INDESIT company

BA35FNFGR

F033773

RE0231T0 (... - 61112...) Exploded views

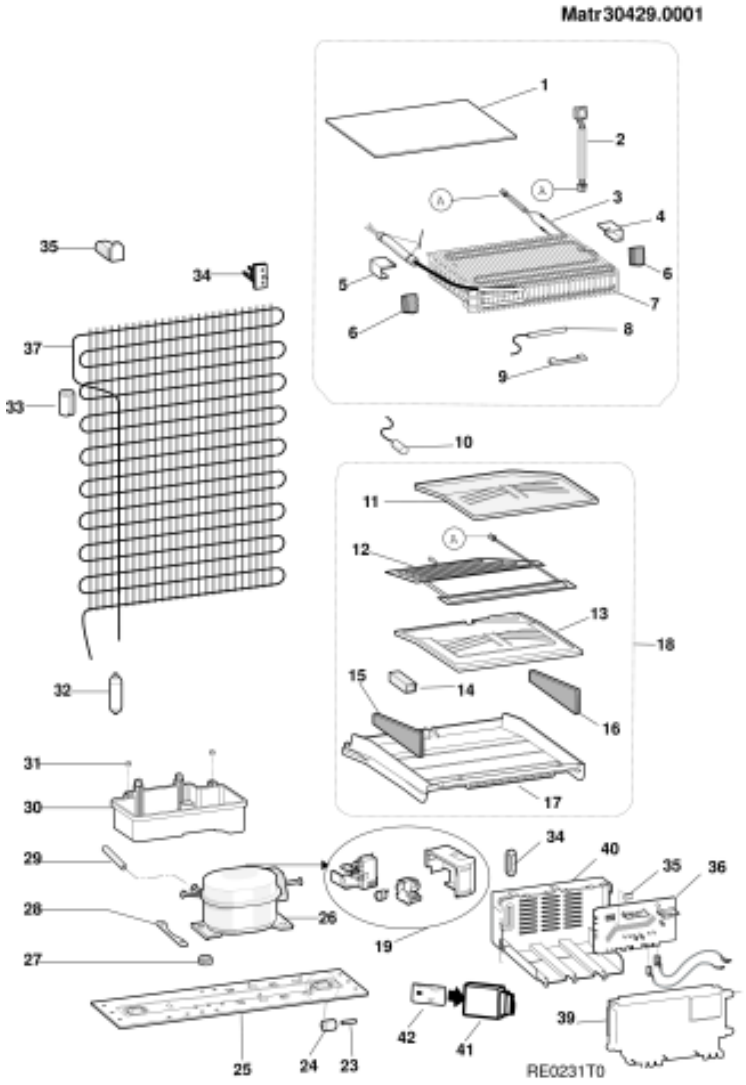
0999364: new fin evaporator and rezistance

Since 01/04/05 new fin evaporator end new rezistance will be used on EU combi models. New parts as an assembly can be used on the appliances which are produced before the modification.

To fit new evaporator follow below procedure;
· First of all fin evaporator should be positioned at right and back of the freezer roof and than right bracket should be screwed like previous manner (the same track of the hole for right bracket exists on the cabinet). Use the evaporator as a template to screw and position the left bracket symmetricaly.

0999376: ICE FORMATION AT THE BACK OF THE EVAPORATOR

Below modifications have been performed to prevent ice formation at the back of the evaporator on L70 combies. These new parts can be supplied as an assembly C00141277
1- Spugnetta evaporatore left and right have been modified since 12/08/2005. Spare part codes remain the same (C00094468-C00094467). These parts must be replaced together in case of necessity of the replacement.

2- Power of the rezistance for divisorio camere has been increased from 40W to 50W since 03/10/2005. Spare part code remains the same (C00095774).

3- Power of the rezistance for evaporator has been increased from 140W to 150W since 26/09/2005. Spare part code remains the same (C00115199).

4- Drain hose end piece C00141278 has been used for draining the water to the evaporating tray since 26/09/2005.

5- Fan motor plastic assembly has been modified. The hole for propeller has been modified to prevent friction between propeller and fan motor plastic since 03/10/05.
Spare part code remains the same (C00116498).

RE0250T0 (... - 61112...) Exploded views

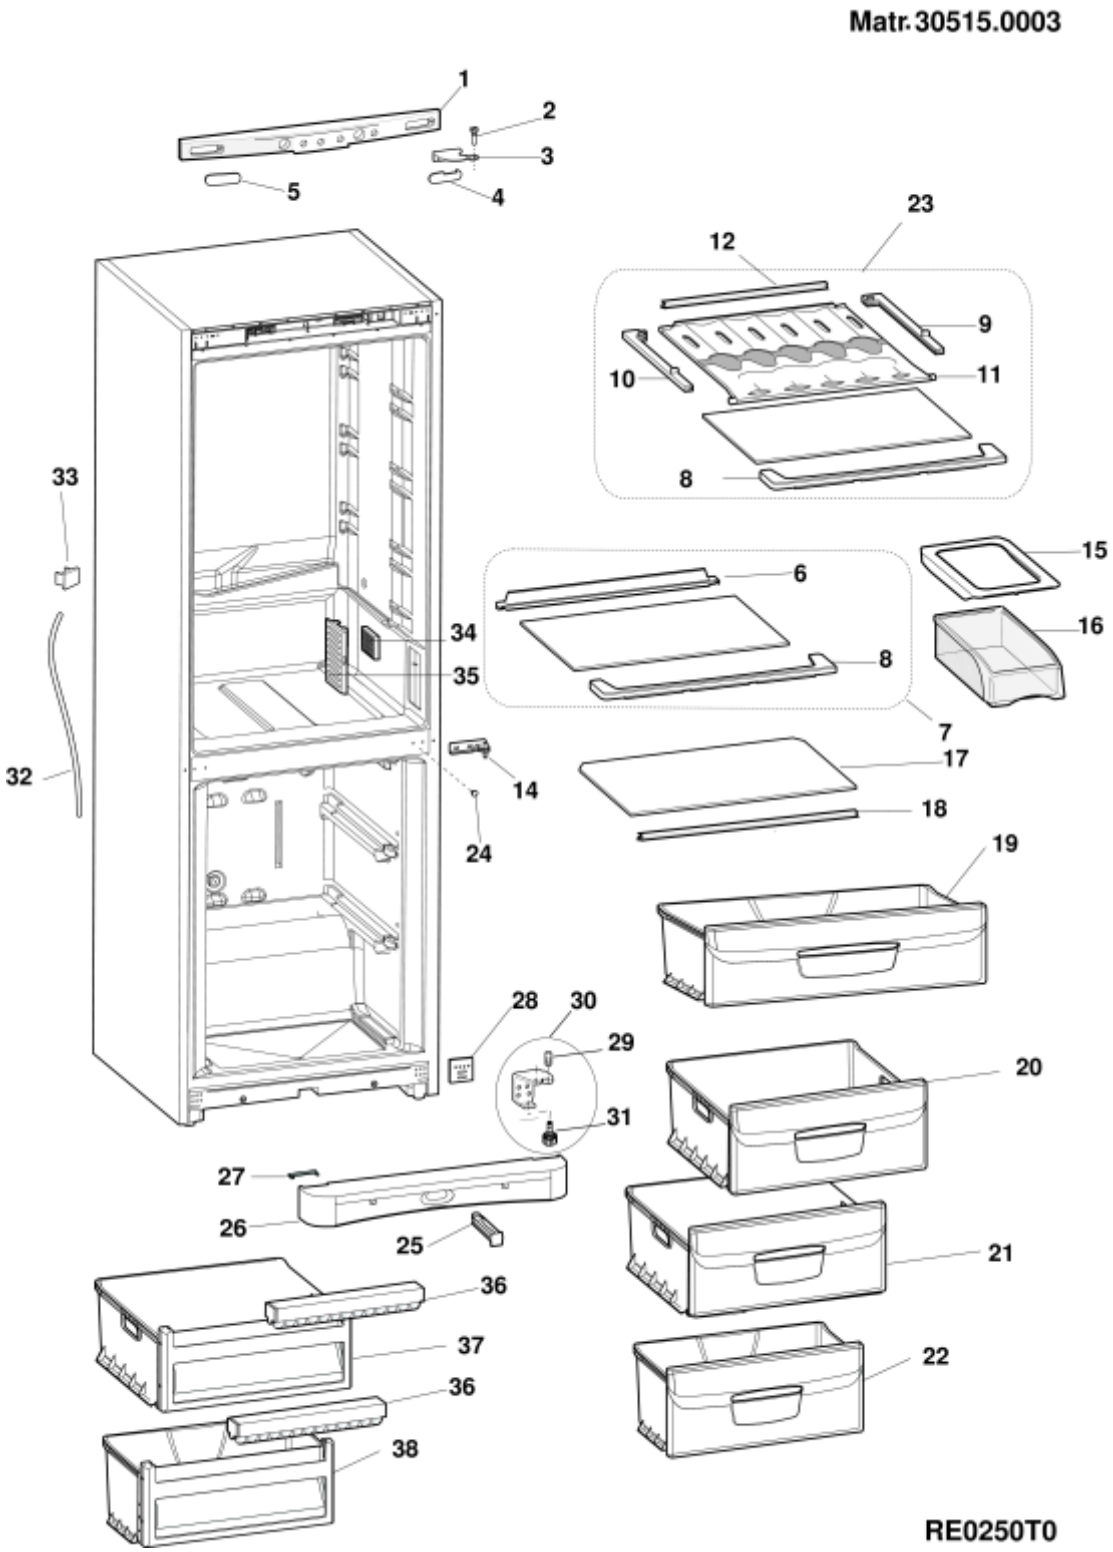
0999368: color modification

Since April 2005, color of products has been changed from Bianco 27 to Polar White in Manisa Plant.

n3010b02: PLAYZONE ELIMINATION

Playzone shelf has been eliminated in Manisa and Lodz production and replaced with a normal shelf already present in interested models.
These spare parts will not managed at the end of stock.

RE0252T0 (... - 61112...) Exploded views

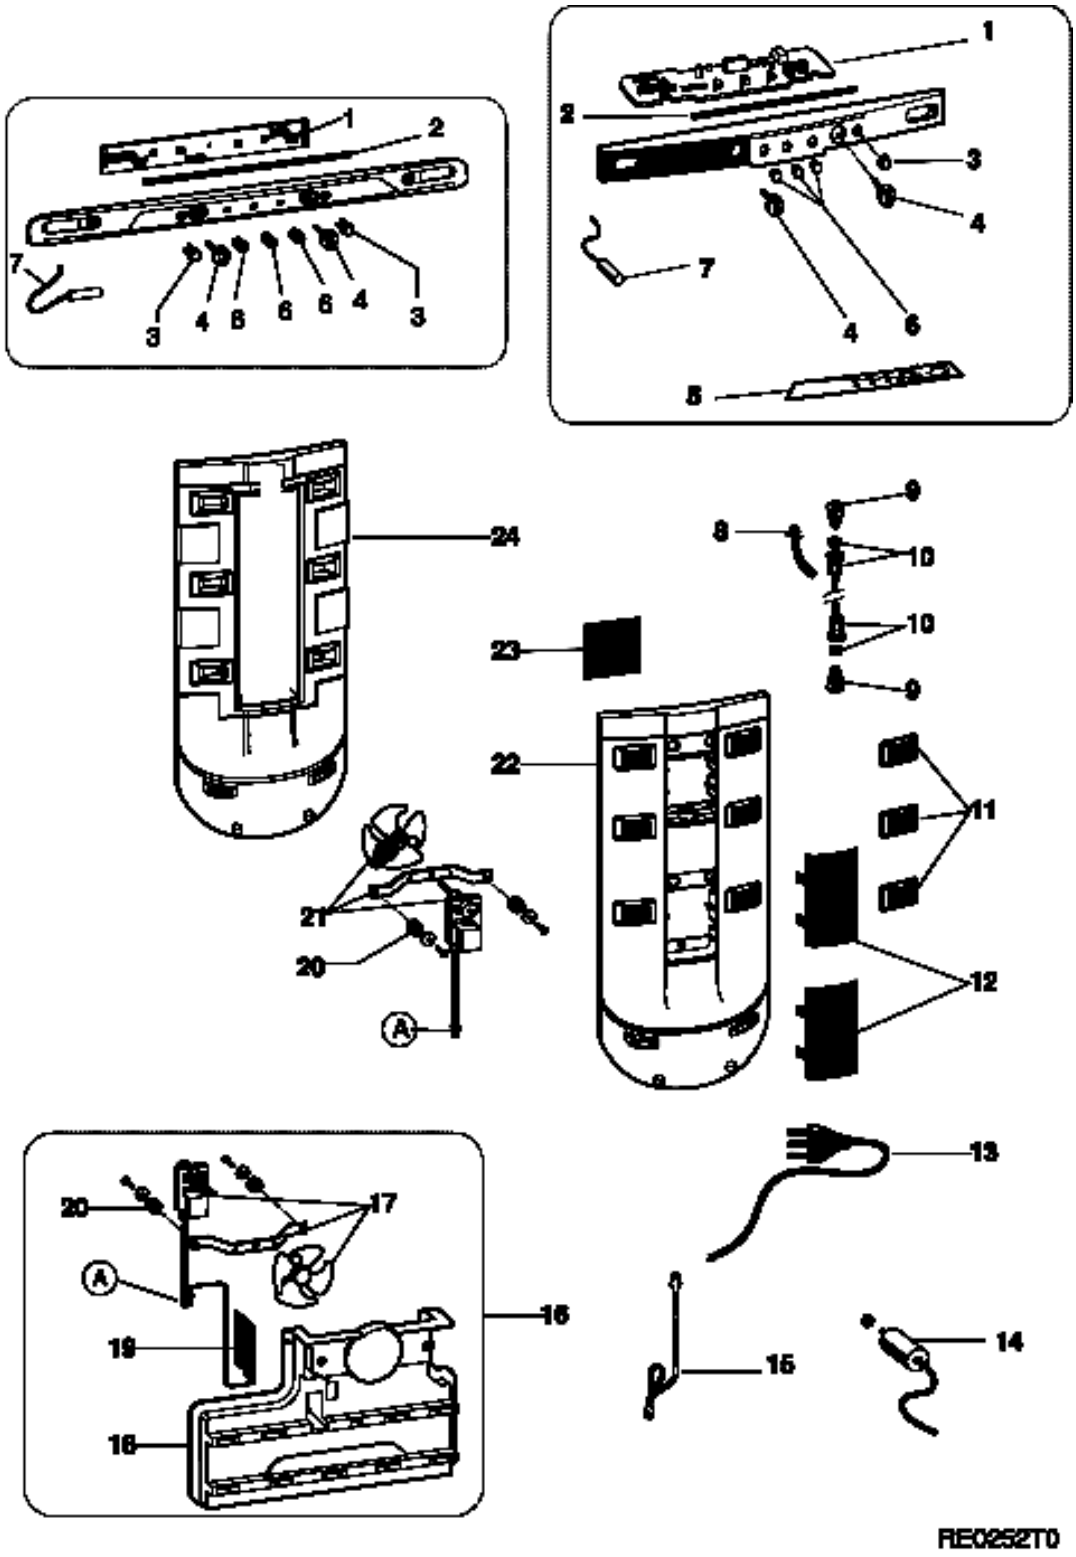
0999379: TWO HOLES HAVE BEEN CANCELLED ON MULTIFLOW FOR COMBIES

Due to low temperature at the lower part of the fridge section on Manisa combies two holes which are placed on multiflow cover have been cancelled for all combies since 13/04/2006.

re0290t0 (61113...- ...) Exploded views

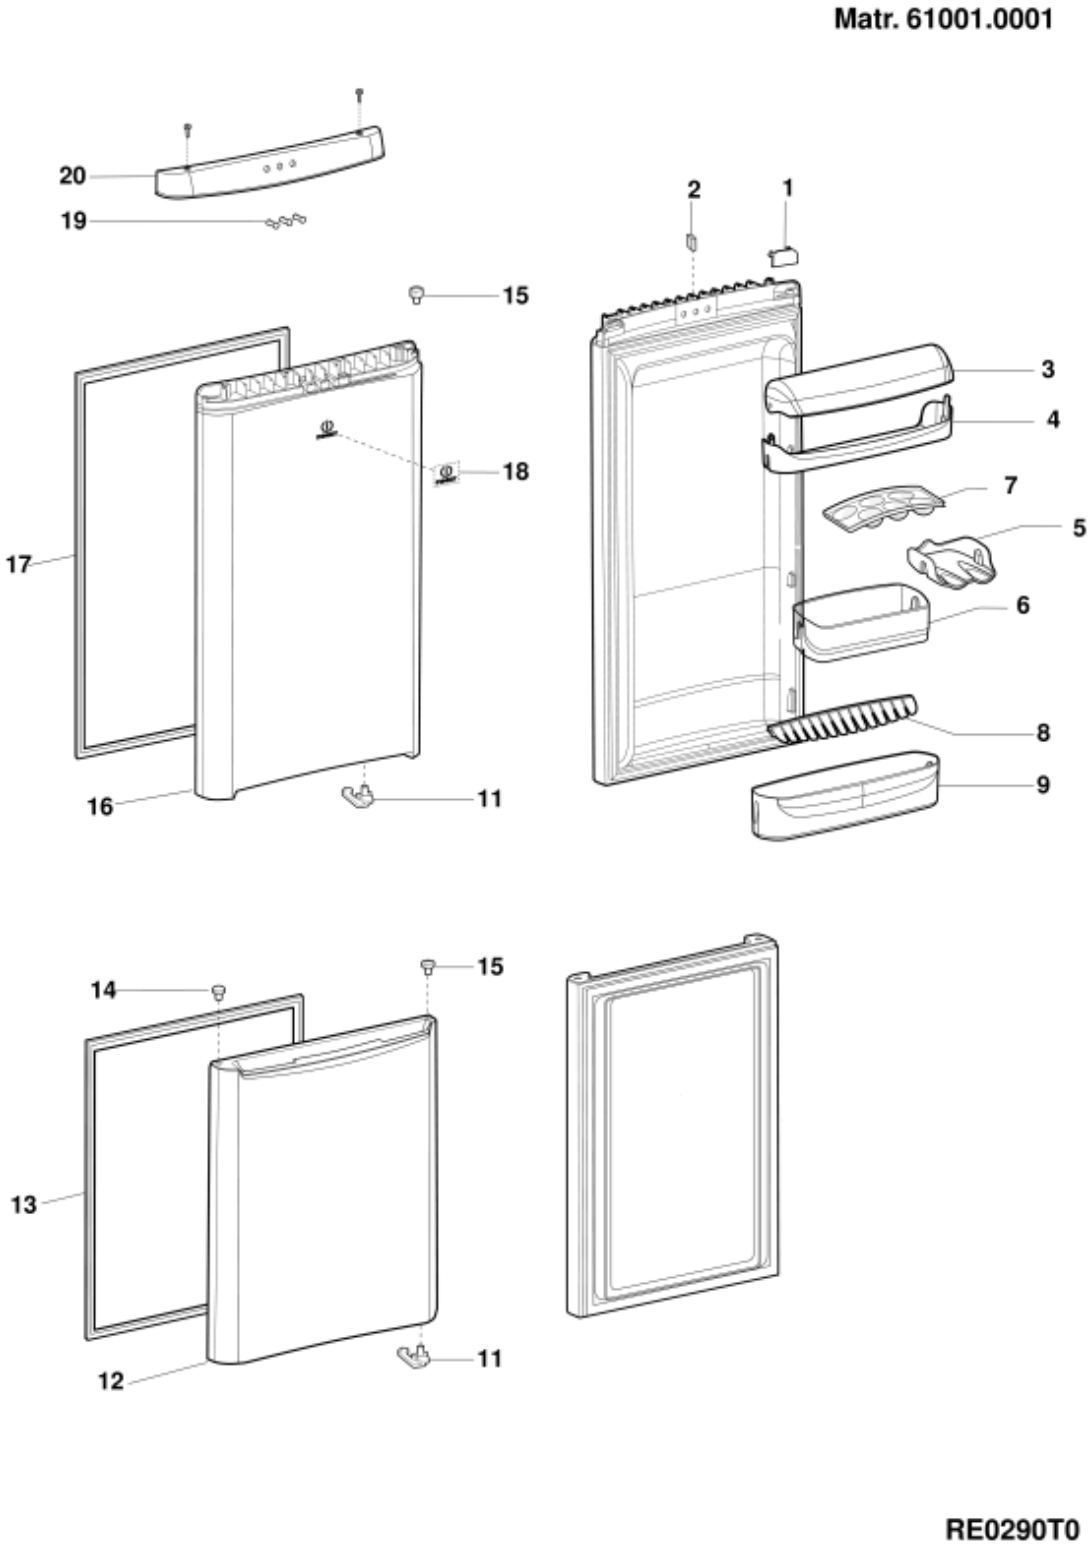
n3011e00: CHANGED EGG HOLDER FROM PW TO TRANSPARENT
